25 Gbd/s Stressed RX Sensitivity (SRS) in 802.3ca

- Notes on D2.0 Cmt. 418 on SRS

D2.0 - Comment #418 on SRS
SC 141.5.2

Our Current 25G SRS Spec – J2, J9, VECP (from Table 141-17, D3.0)

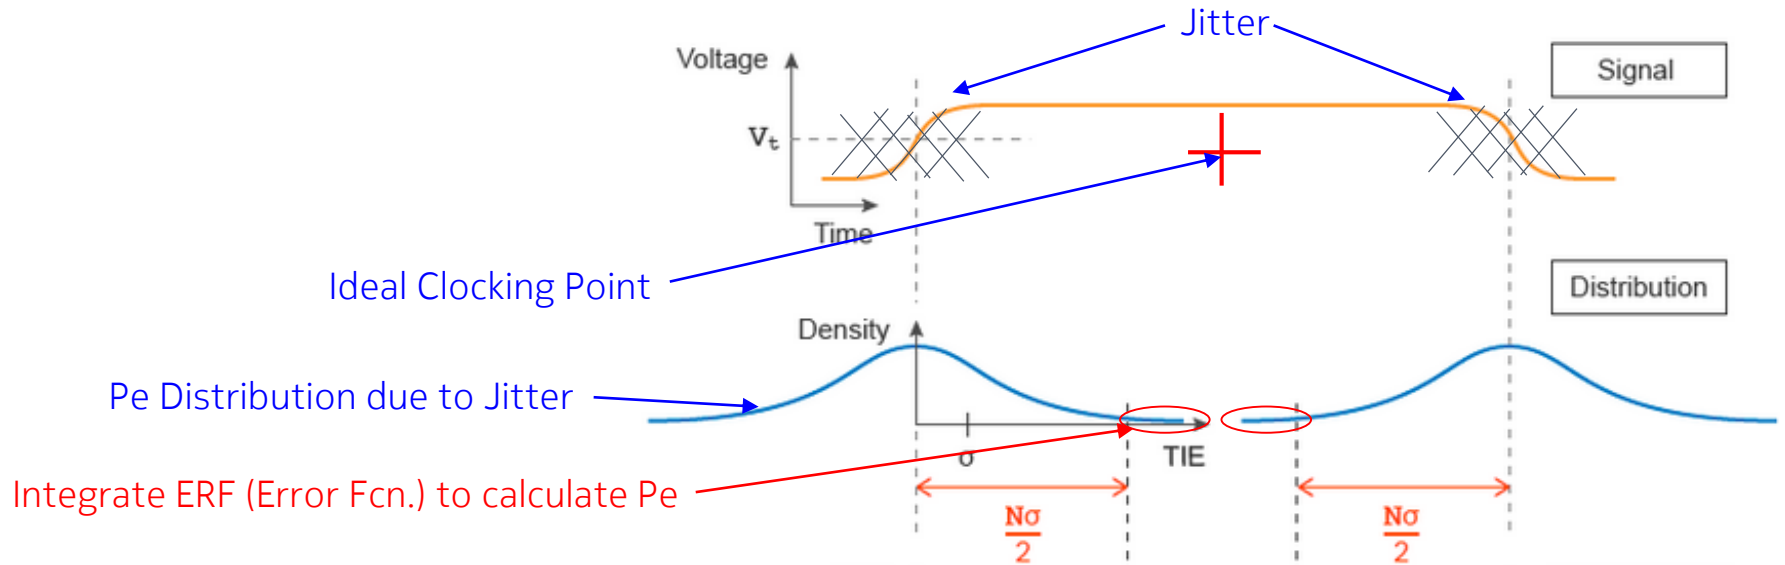
If these PMDs use FEC, probably the stressed receive signal should be defined by SEC, J2 and J4, as 25GBASE-SR, LR and ER, rather than VECP, J2 and J9 as 40GBASE-SR4.

But as the pre-BER is $1e-2$, even J4 is wrong. Maybe Jrms and J3 would be suitable. SEC can easily be defined for a BER of $1e-2$.

The RX stress parameters were indeed copied from 100GBASE-LR4 as a reasonable starting point to enable the draft to move forward. I personally don't have the background to derive them from first principles for the 802.3ca PMDs, so it will be up to someone else with the knowledge and interest to do so. In the end it likely doesn't matter much since I'm not aware of any PON module vendor using stressed receiver testing in manufacturing.

I agree with your recommendation. I think it's still OK to keep our current J2/J9 and VECP levels. I think Tamura-san's SRS BER measurement data is nearly equal to 802.3ca spec if the receiver were APD. I think our current levels are reasonable.

- Our .3ca optical experts have considered the concerns raised in comment #418 from D2.0 on our 25 Gbd .3ca SRS specification in our draft
- They don't think our current VECP, J2, J9 SRS specs are an issue as stressed receiver tests are not normally used by PON module vendors in manufacturing and that our SRS specifications are at reasonable levels
- We have considered the concerns raised in D2.0 comment #418, and in the absence of a specific proposed change, propose to keep our current 25 Gbd SRS requirements
